Village of Arlington Heights
Plan Commission
Board Room, 3rd Floor
Village Hall 33 S Arlington Heights Road
August 28, 2019
7:30 PM

- A. McDonald's - 45 E. Golf Rd. - PC#19-010
PUD Amendment
- B. Northwest Crossings - 1501 W. Shure Dr. - PC#19-011
PUD Amendment, Variations

RE: ARLINGTON MARKET/SF HOMES - 1-5 & 9-52 N. BEVERLY LN. - PC# 19-008
SINGLE-FAMILY HOMES - PUD AMENDMENT

A02-00B

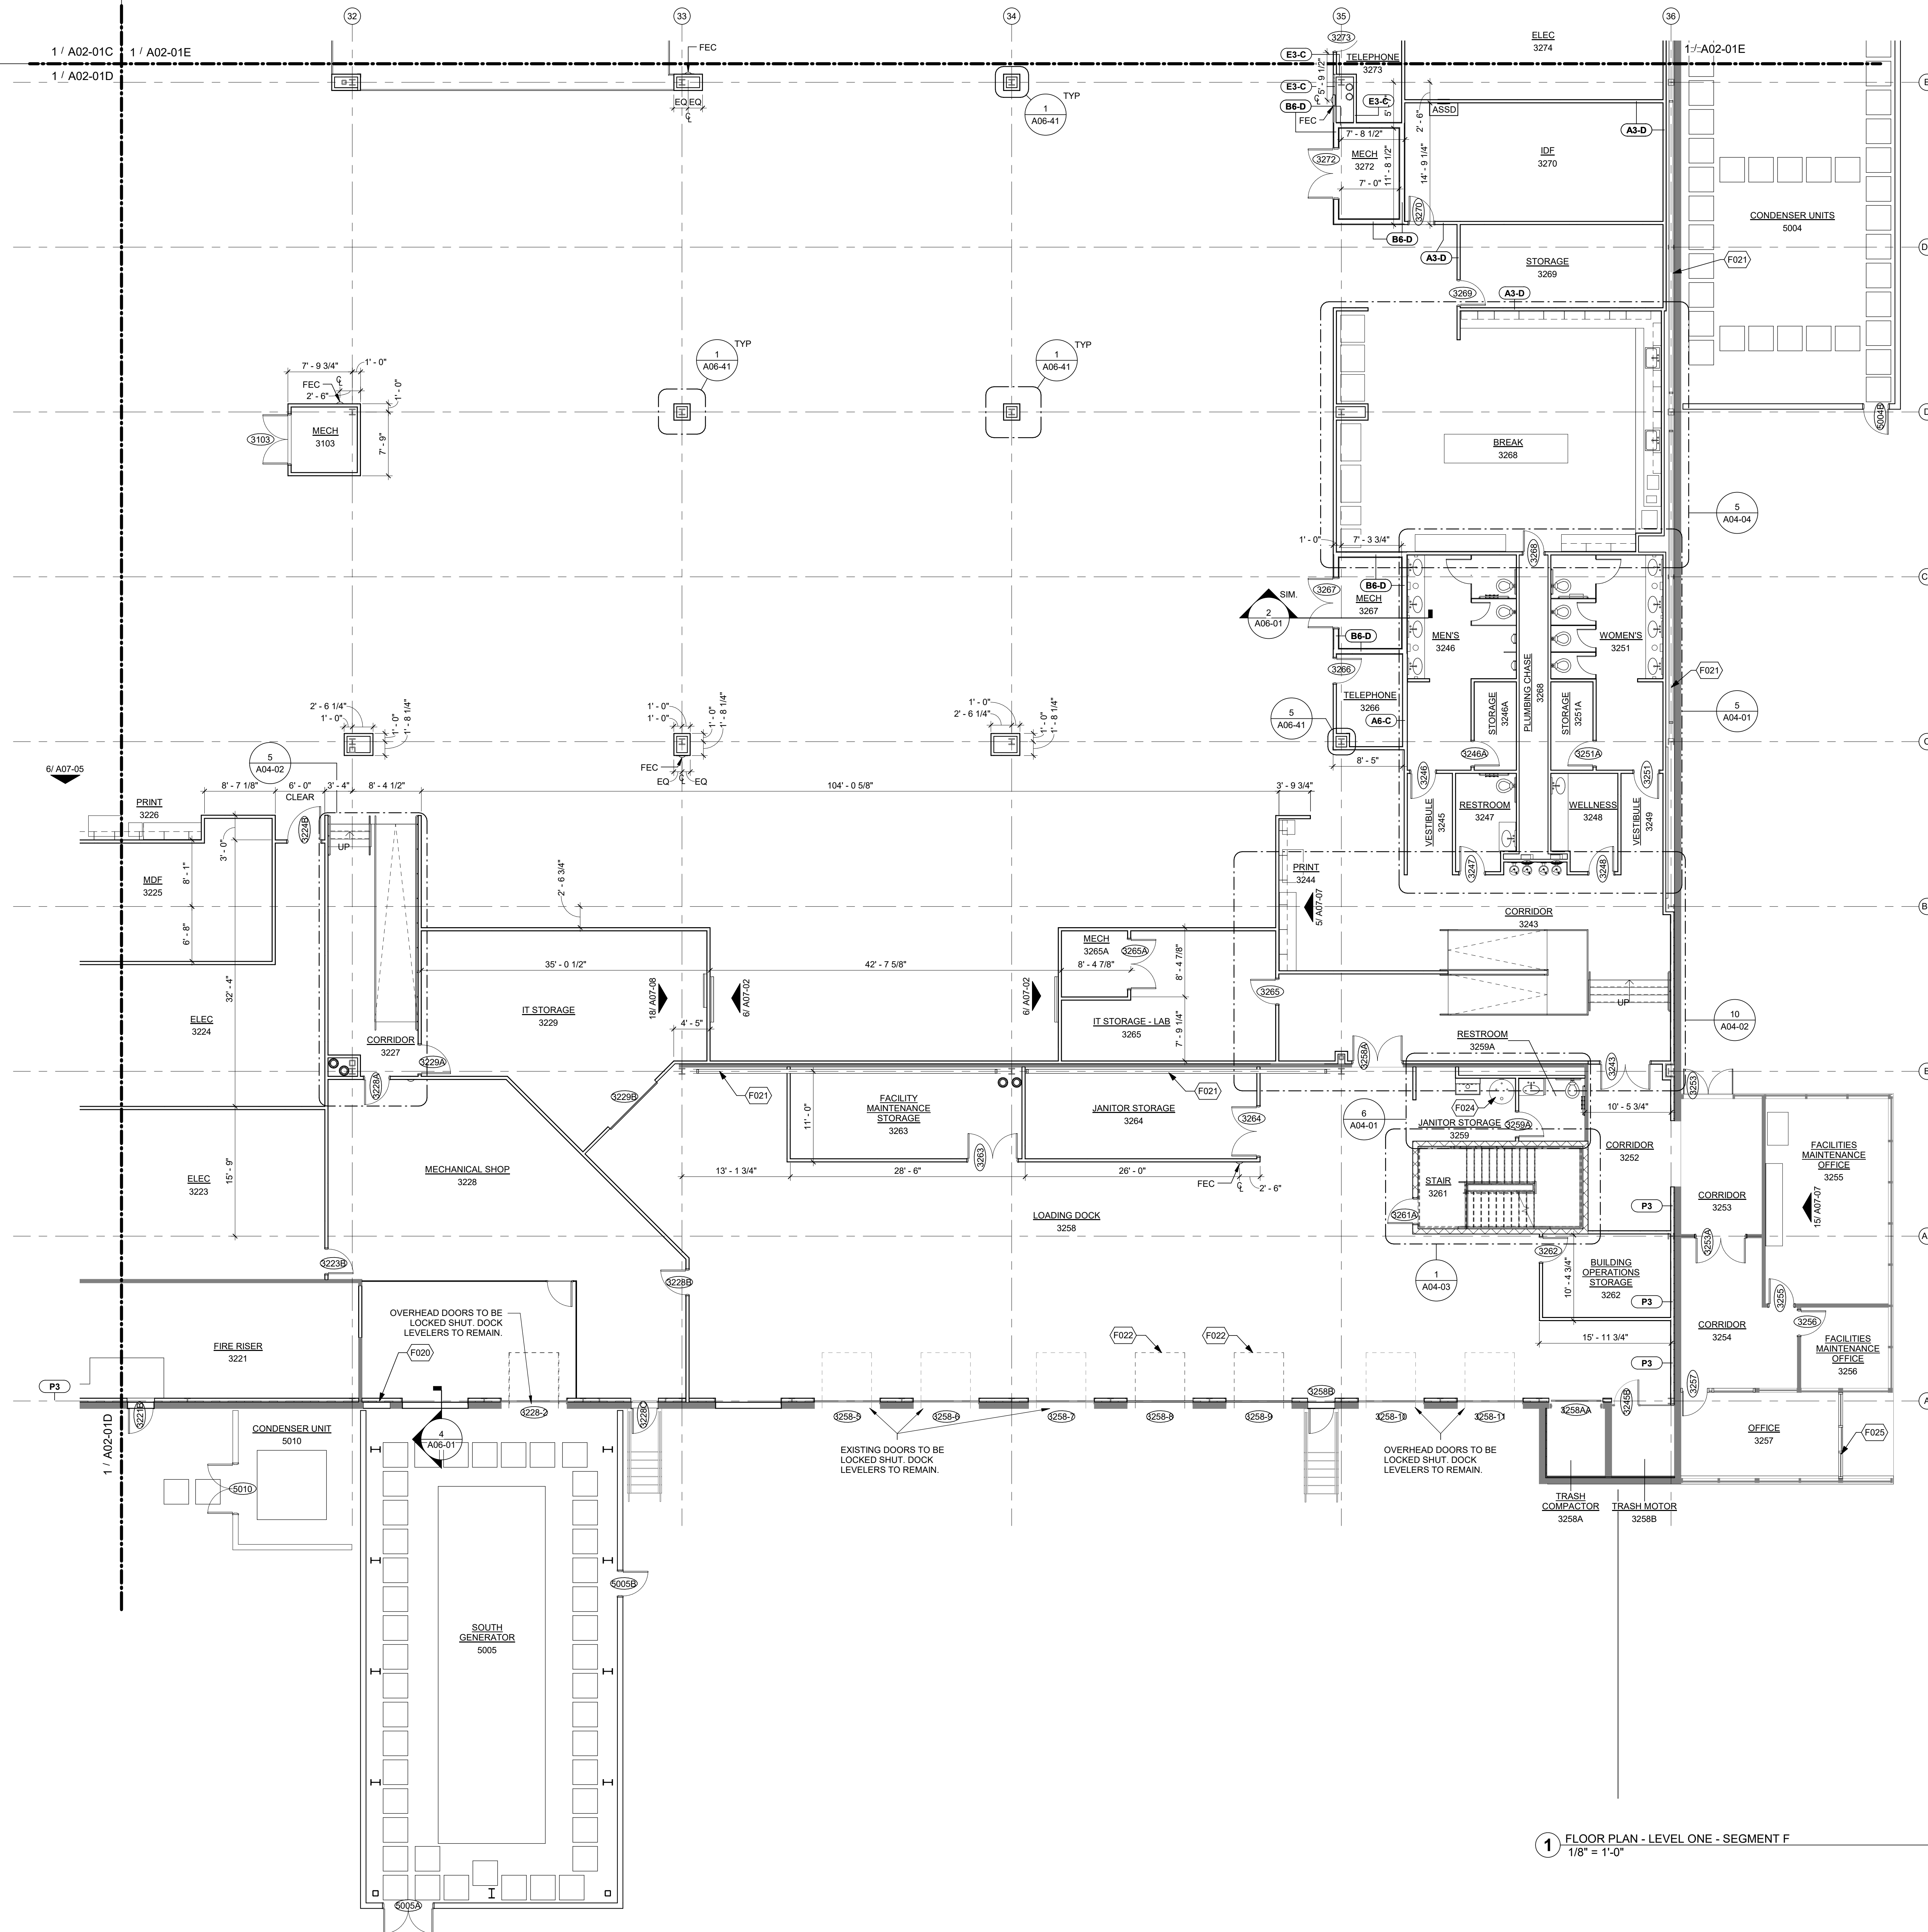
15. On sheet A02-00B, please clearly delineate what arears are included in Phase I and Phase II and add the total square footage included within each phase (total square footage should match value of 195,300 sq. ft. as shown on the other plans).

29. *The response to comment #15 is noted. However, no line delineating Phase I work from Phase II work was added to the floor plans. Please clarify if the 68,253 sq. ft. Phase II area consists of the area that is hatched and labeled "Unoccupied Area" (4001) on sheet A02-00B.*

Response: Yes, a line has been added to Sheet A02-00B. And yes, the Phase II work is the unoccupied area of 68,253 SF.
